STAFF RECOMMENDATION: Approval with Conditions.

SUMMARY

Stoneyhurst Quarry covers 13.31 acres on the north side of River Road, west of the intersection of River and Seven Locks Roads. The reserves for the quarry are approaching exhaustion, and because of its unique configuration and topography, the site is appropriate for multi-family residential development. Most of the site is excavated to elevations of 150 feet to 175 feet, forming a crater with exposed rock formations. A perimeter zone of approximately 100 feet of forestation remains undisturbed at elevations ranging from 175 feet to 225 feet.

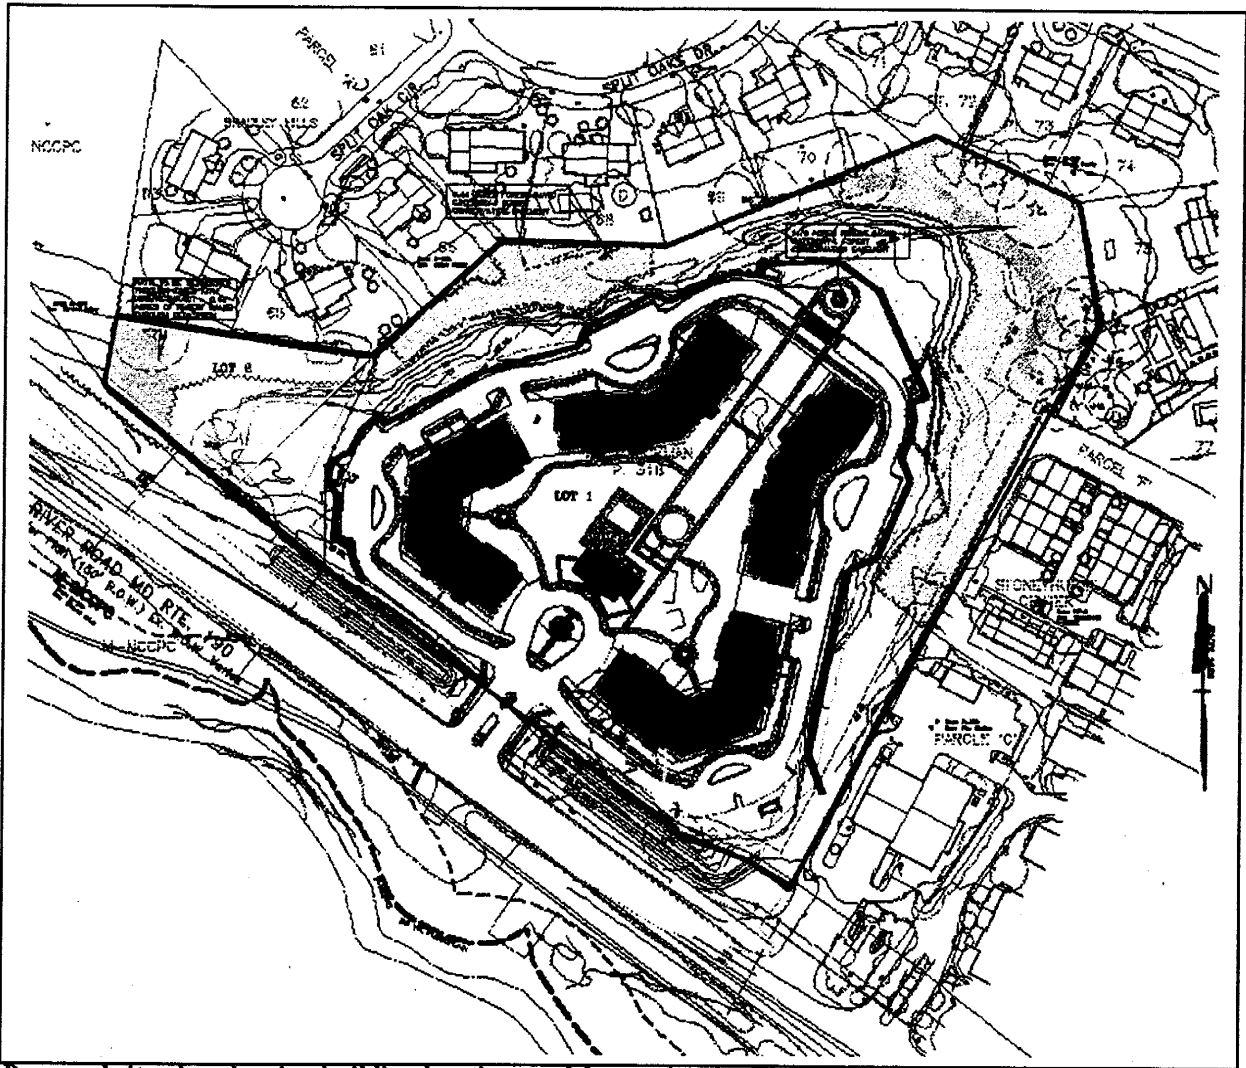
Staff finds that the Project Plan, in accordance with the recommended conditions, will be in substantial conformance with the Potomac Subregion Master Plan, the intent of the RMX-1/TDR Zone, and other project plan findings as required by 59-D-4.42 of the Montgomery County Zoning Ordinance. Staff recommends approval of this proposal, as comprised of 100% multi-family housing because it is more desirable for environmental reasons and is more compatible with adjacent development (as noted in the Master Plan), than would be development comprised of 15% one-family homes. Per Section 59-C-1.395, the Planning Board may waive the requirement for 15% one-family homes based on these reasons.

Section A-A₁ (SOUTH)

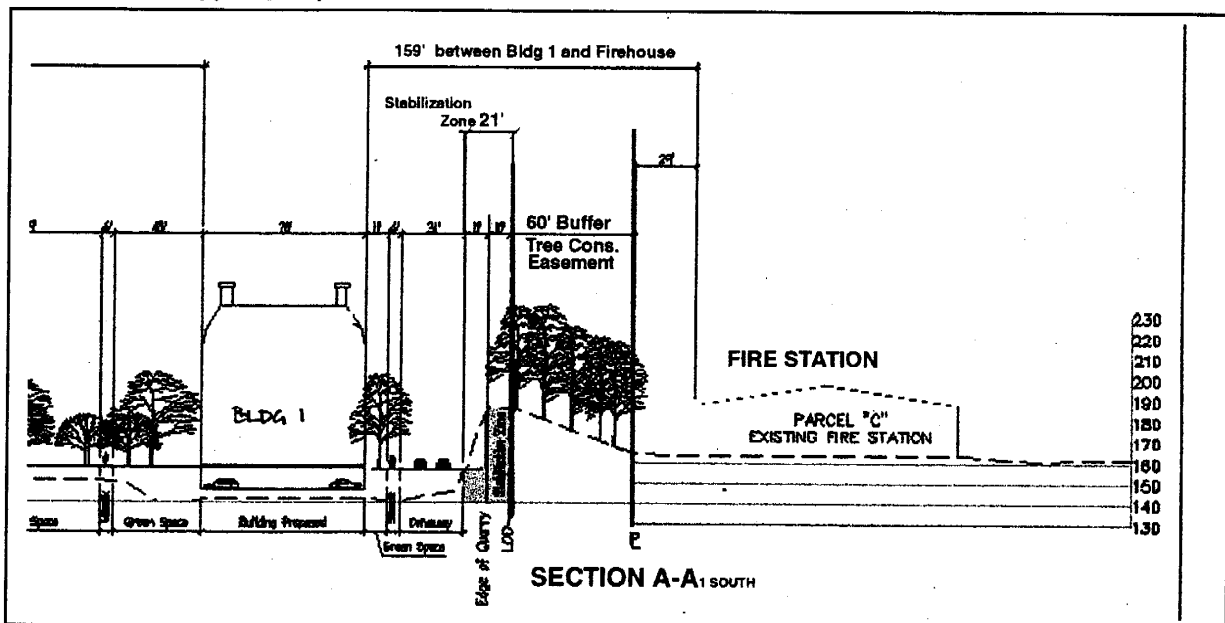
Section view of the southern portion of the site, looking East. The Fire Station is on the right. There is a minimum 60 foot wooded buffer. The Stabilization Zone is 21 feet.

Section A-A₁ (NORTH)

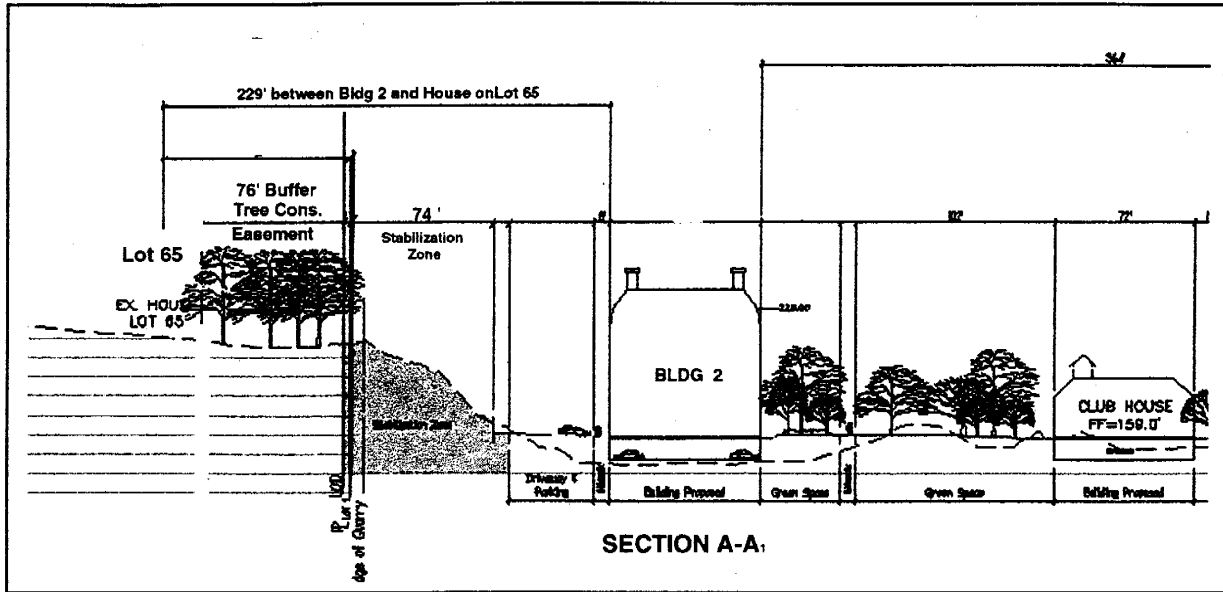
Section view showing the northern portion of the site, looking east. Lot 65 is at the far left. The 76-foot wooded buffer includes a portion of the parkland to be dedicated to M-NCPPC.
